Schmidt Parcel – District Infrastructure

FINAL DRAINAGE REPORT

PCD File No. CDR2413

December 2024

PROPOSED CONDITIONS DRAINAGE MAP

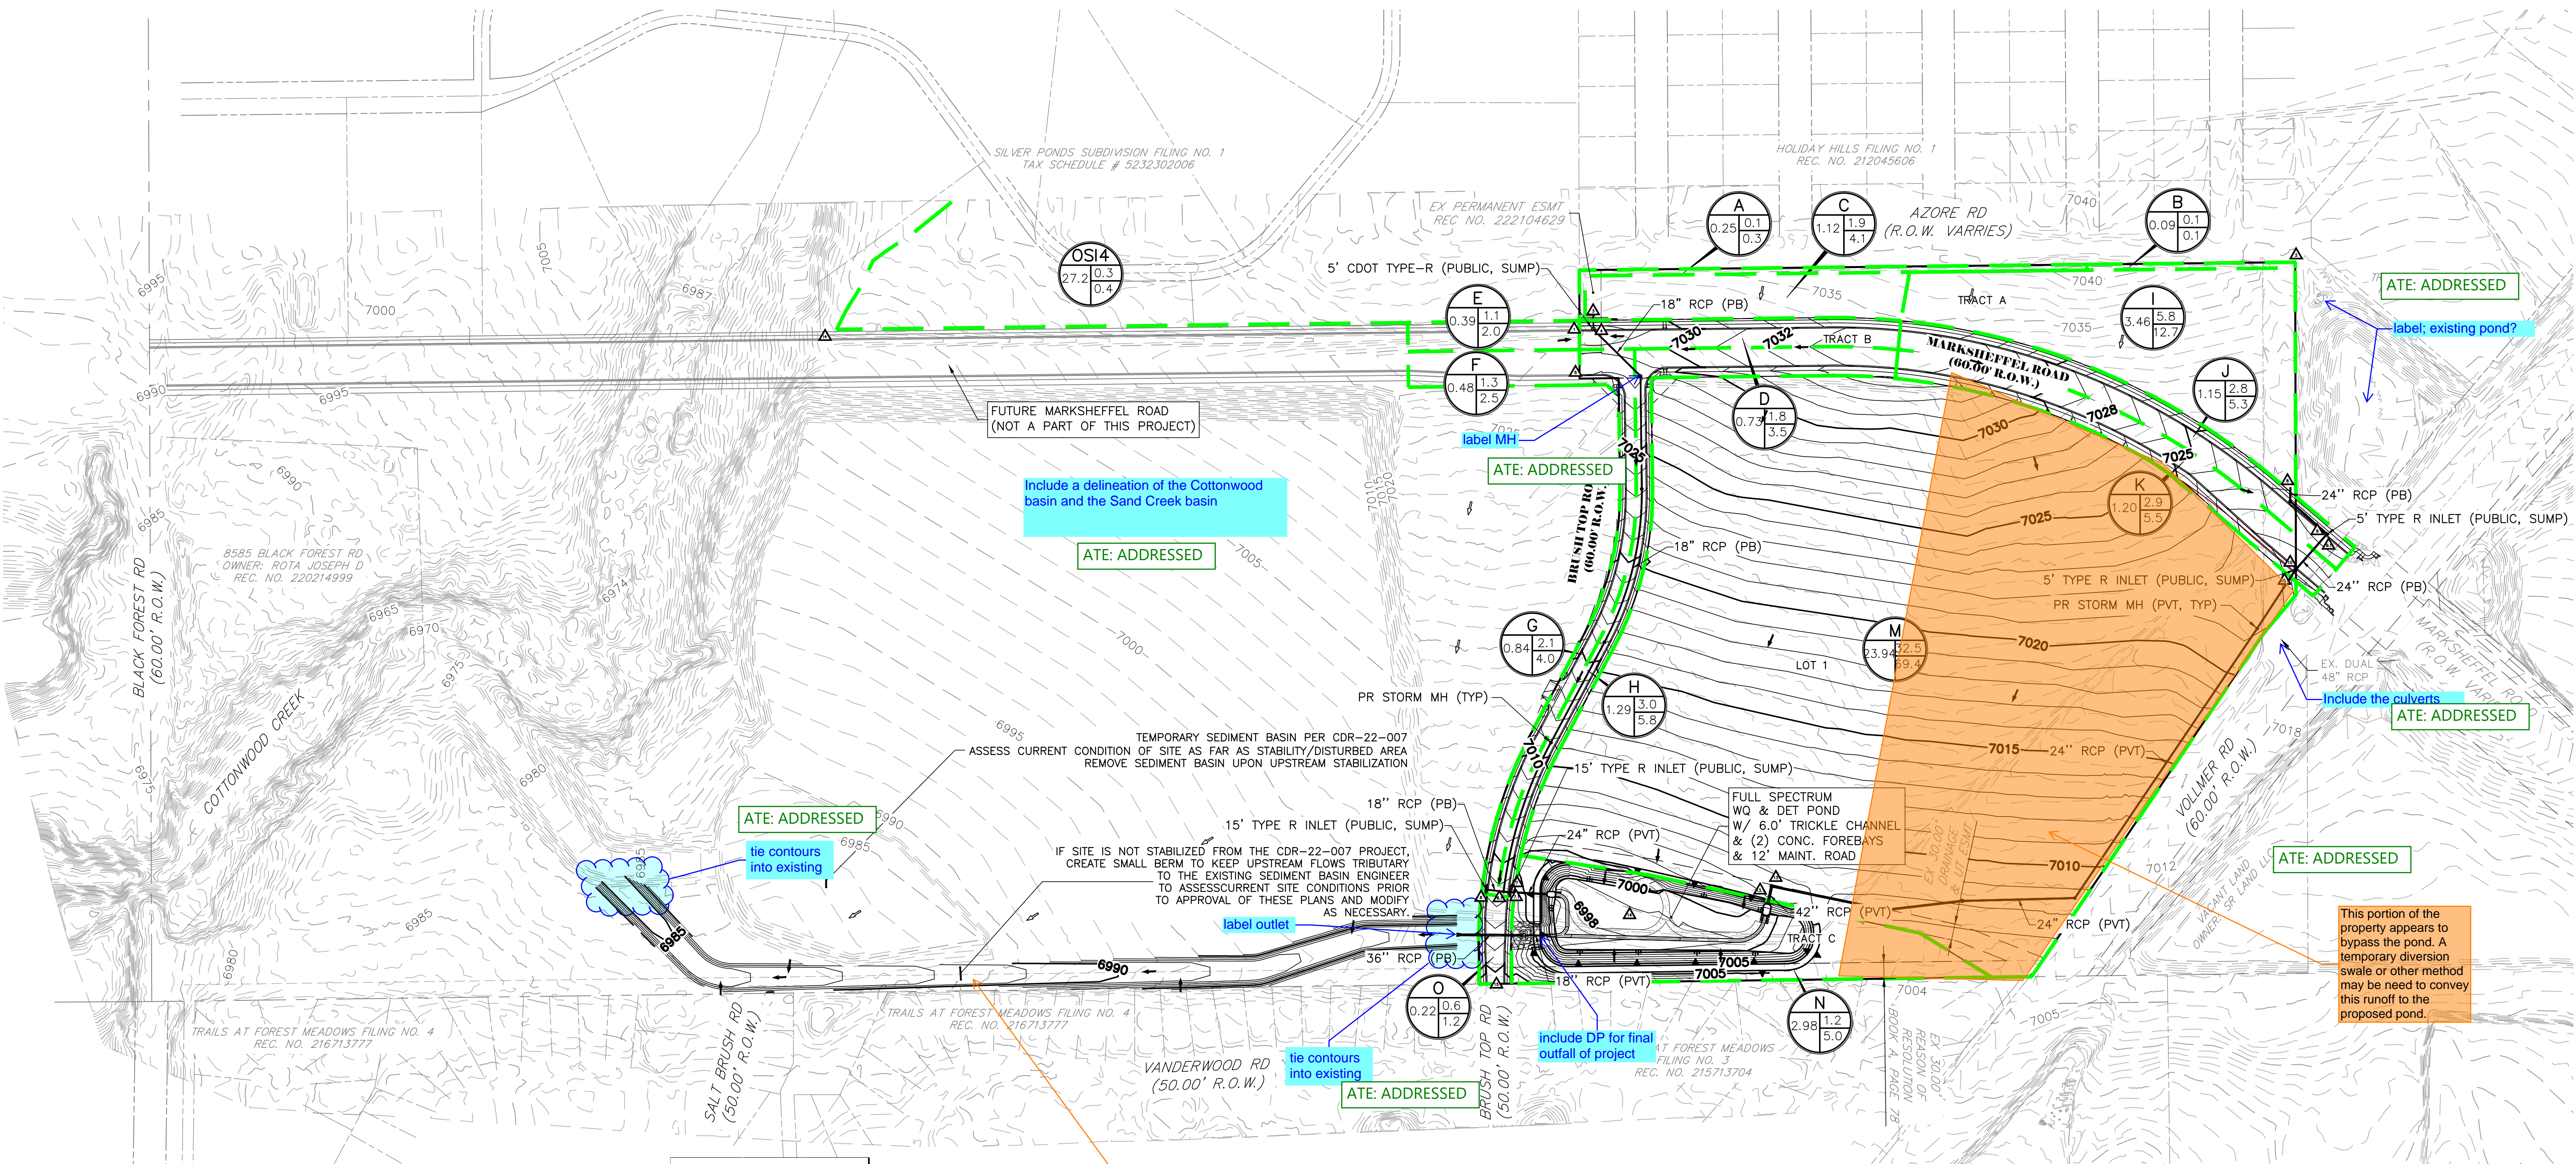
This channel is part of the proposed project and existing and proposed watersheds should be delineated for this area as well.

ATE: ADDRESSED
